Service Bulletin SB-0009

Subject: Main landing gear damper replacement, clearance inspection, and repair.

Effectivity: K003-K006

Affected Model(s): E1000

Figure 1: Main landing gear damper.

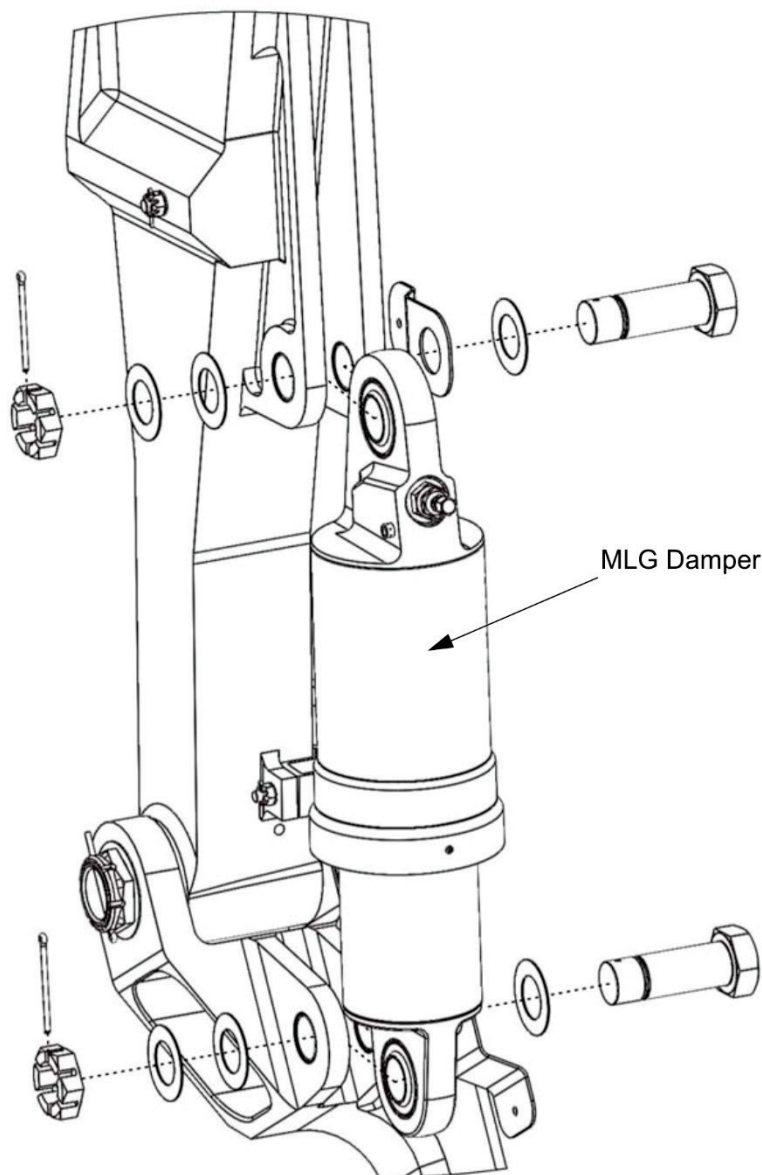
It has been found that some aircraft may not have adequate clearance between the main landing gear damper charging valve and the wheel well liner.

This Service Bulletin gives instructions to replace the left and right main landing gear dampers with assemblies that allow for proper clearance and repair any damage that may have occurred from inadequate clearance.

A) Visually inspect the left and right wheel well tunnel liners for damage due to contact with the damper charging valve.

E) Do the operational test of the landing gear system (refer to the E1000 AMM PN SK05000000, chapter 32-30). Make sure the clearance between the damper charging valve and wheel well tunnel liner is at least 0.25”.

D) Replace the left and right main landing gear dampers as follows:

8) Install the reworked left and right MLG dampers, PN AK32101300 D- (refer to the E1000 AMM PN SK05000000, chapter 32-10).

NOTE: If the clearance is less than 0.25”, contact Epic Aircraft for disposition.
